APPLICATION FOR URBAN DESIGN COMMISSION

Re: 2200 South Park Street - Access Community Health Centers - Initial/Final Review

Attached are 14 copies of the submittal for the new Access Community Health Centers clinic. The exterior building images have been revised to reflect the comments we heard at the meeting on November 28th. Below is a synopsis of the comments we took away, and how our design has been changed in response.

Villager Mall Key Plan

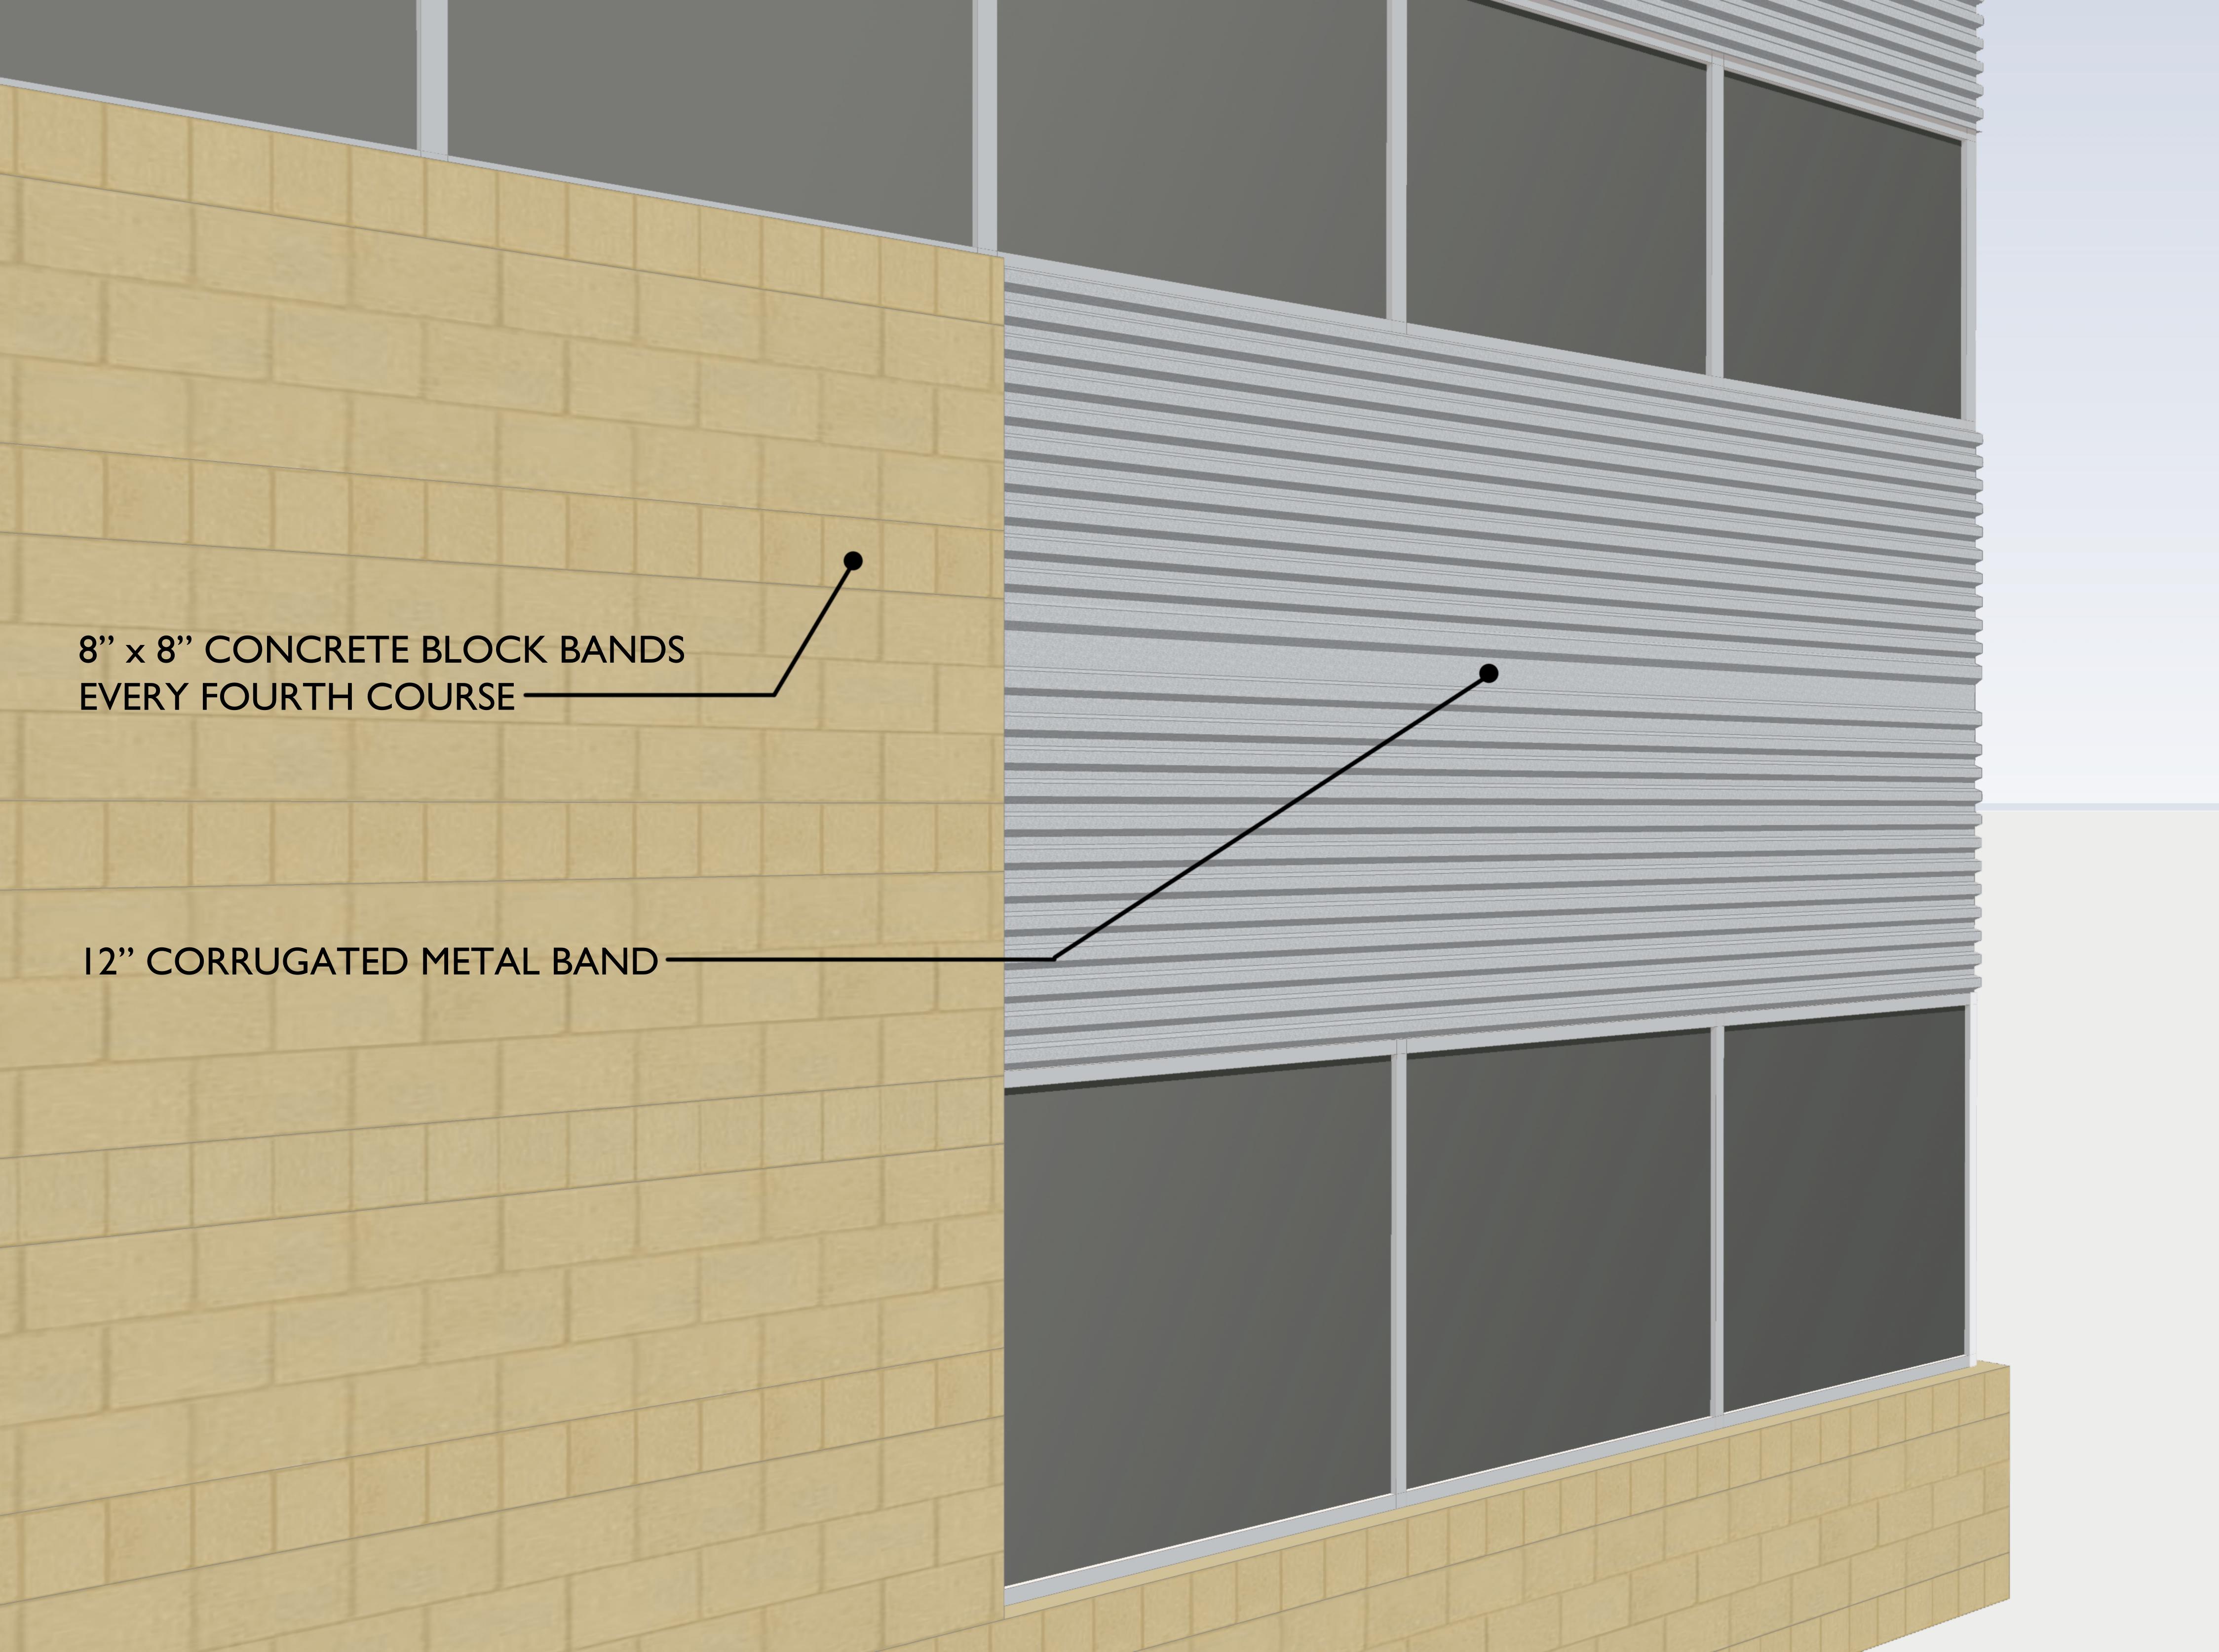
- A comment was made that it seems there are more trees shown in the original master plan than proposed in the landscape design. Comment was also made on the pedestrian connections to the overall site.

- a. The Villager master plan shows a total of 21 trees within the bounds of what would be considered the Access site, with 13 major and 8 minor trees. The landscape design contains a total of 26 trees, with 19 major and 7 minor trees. We think that this does address the intentions of the master plan and would like to discuss this further at the presentation. We are connecting the pedestrian walkways to the overall site, and have included a master plan sheet with the Access site design superimposed to illustrate this.

EAST ELEVATION

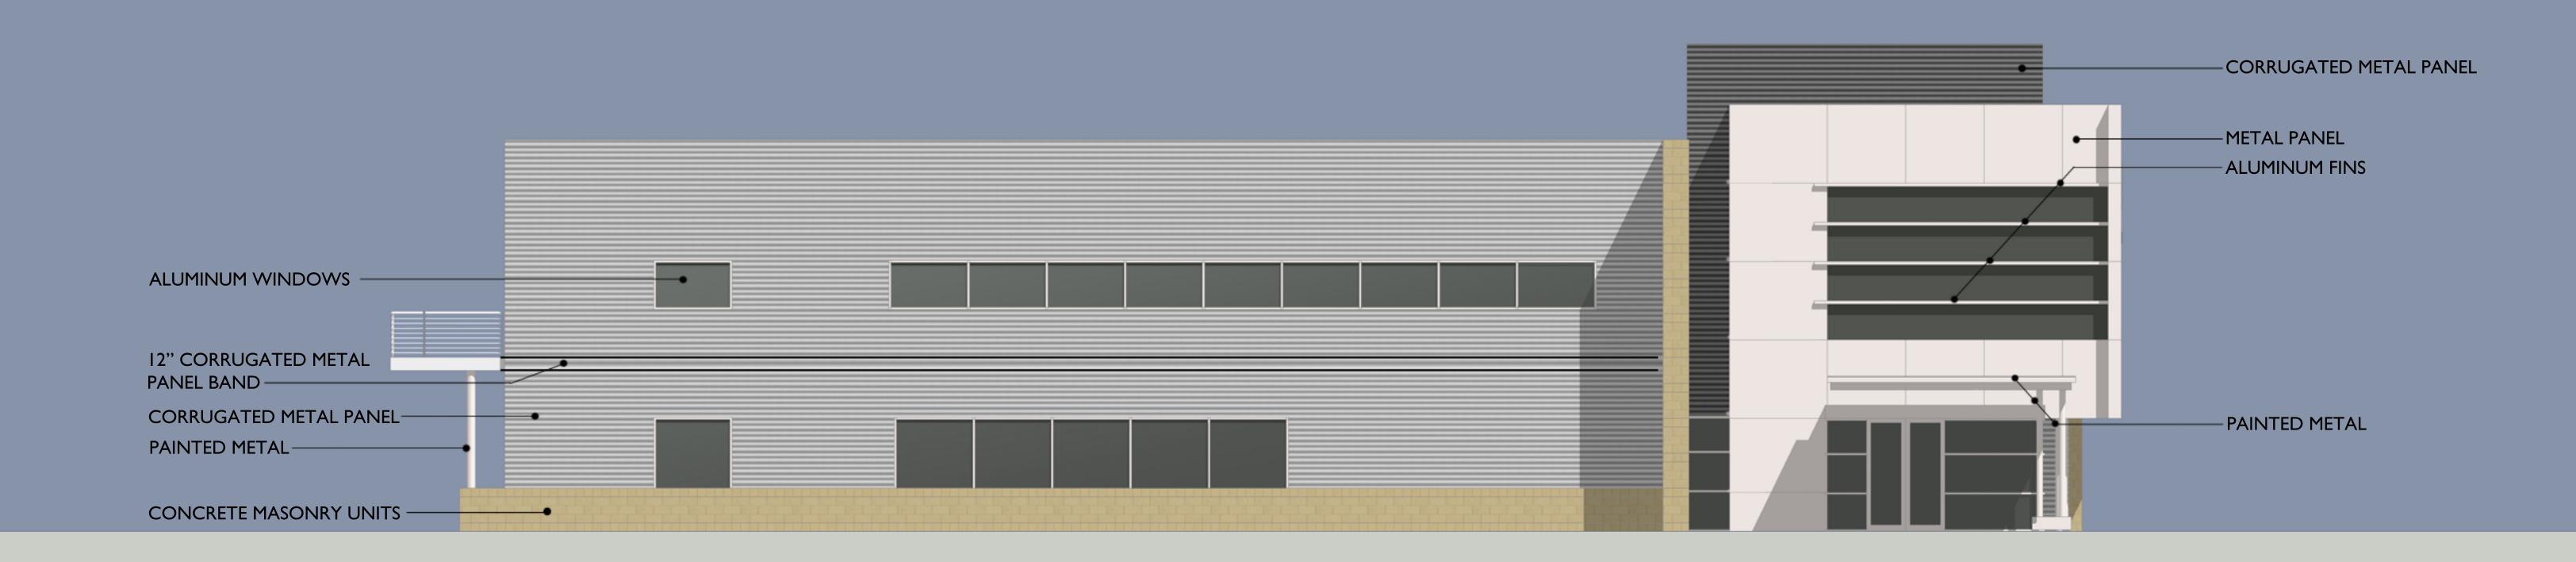
- 3. Look into varying the masonry size or coursing to help visually break up the large areas of block on the East and North elevations.
 - a. We have revised the design and graphics to show how we plan to incorporate bands of 8 inch square masonry coursing in addition to the field of 16 inch long block. This helps to subtly break up the large areas of block and complement the clean, linear design of the building.

SOUTH ELEVATION

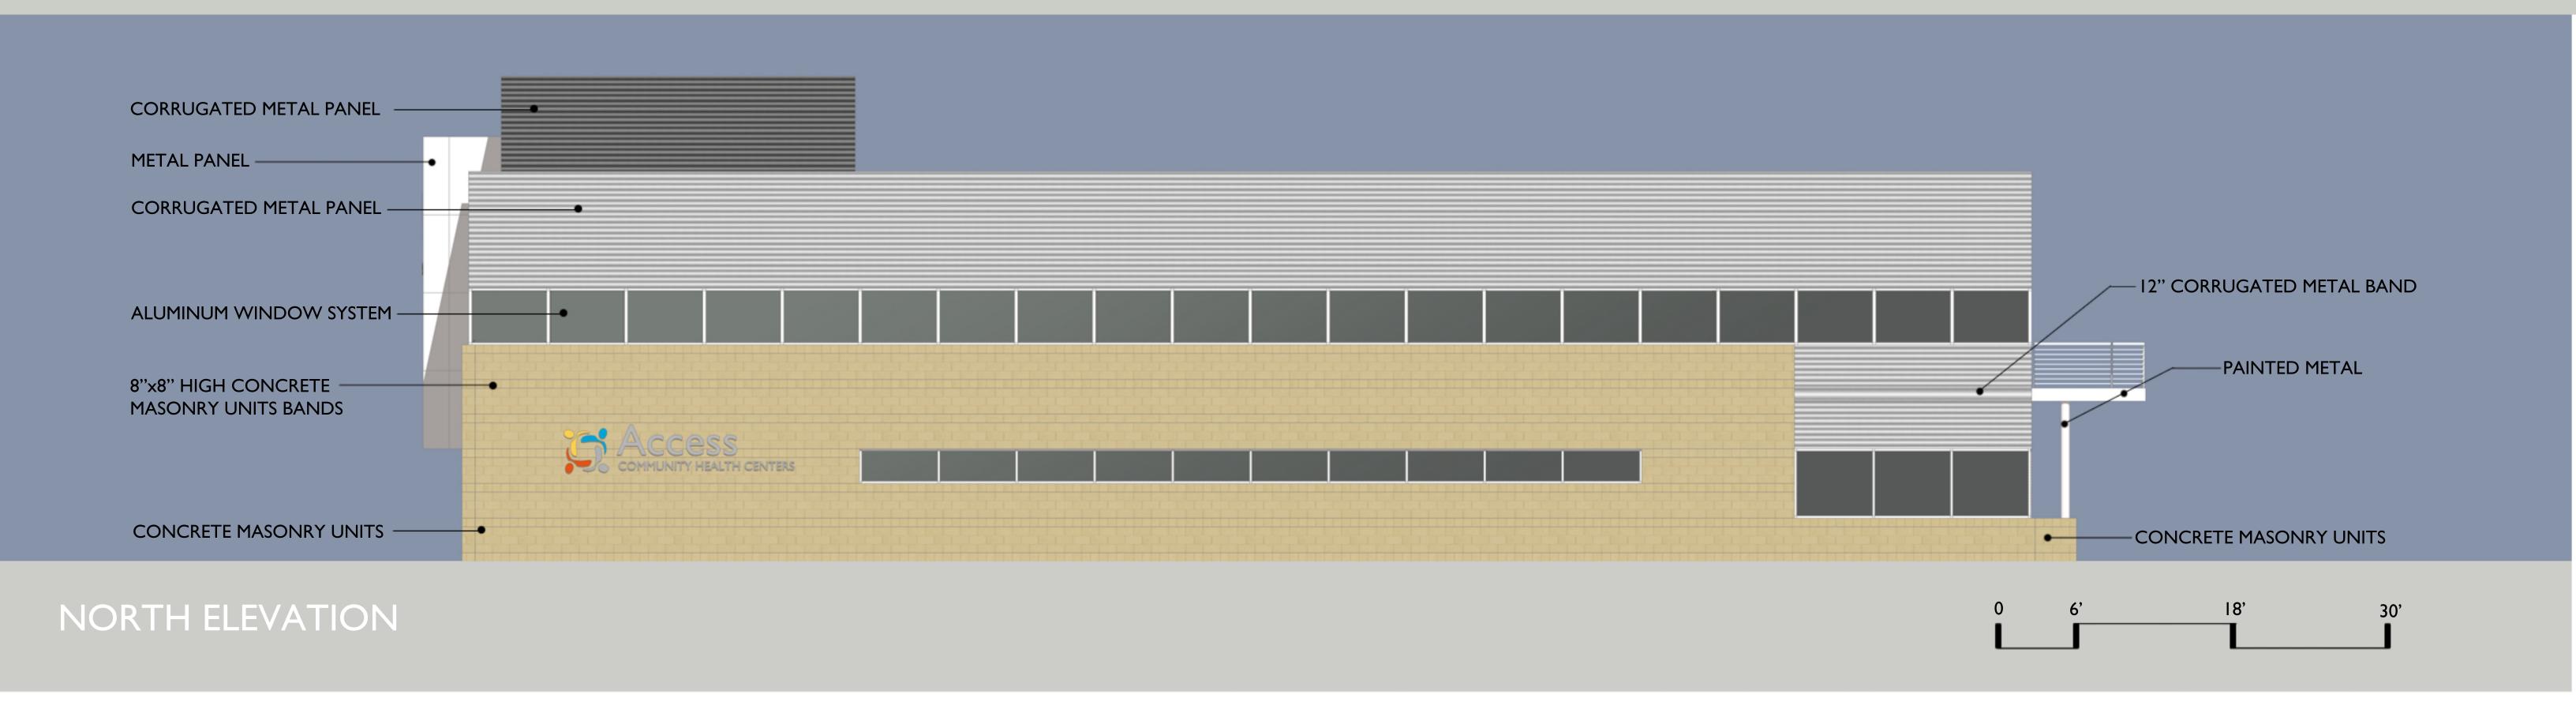
- 4. At the informational presentation, a suggestion was made to somehow break up the large areas of corrugated metal on the South and West elevations.

- 6. The previous informational submittal showed sun shades above the horizontal band of windows on the South elevation. It was felt that the previous edition was better.

- a. This was addressed verbally at the initial/final presentation of the 28th, but the graphics did not reflect the intention. The design intent is to break up the large field of "Minirib" horizontal corrugated siding with a band of "U-Panel" siding which has a wider rib spacing with deeper ribs. Our graphics have been revised to reflect this. The band is placed at the floor line which is a logical place for it and helps add visual interest to the areas of metal.

- a. Adding sun shades back in above the windows on the South elevation was discussed at length with the owner. There are potential performance advantages to them in that they add shading in the summer months when the sun is high in the sky. However, we are using a very high performance clear, reflective low-e insulated glass product. We feel that this responds to the energy and heat gain issue. At this time we think that the addition of masonry coursing and varied metal ribbing helps add interest to the south elevation, and would like to ask for approval without sun shades. The owner's thoughts are that they would rather spend additional funds on serving their patients than sun shades, so it is also their preference to ask for approval without them. We are open to and will welcome further discussion if this at the upcoming presentation.
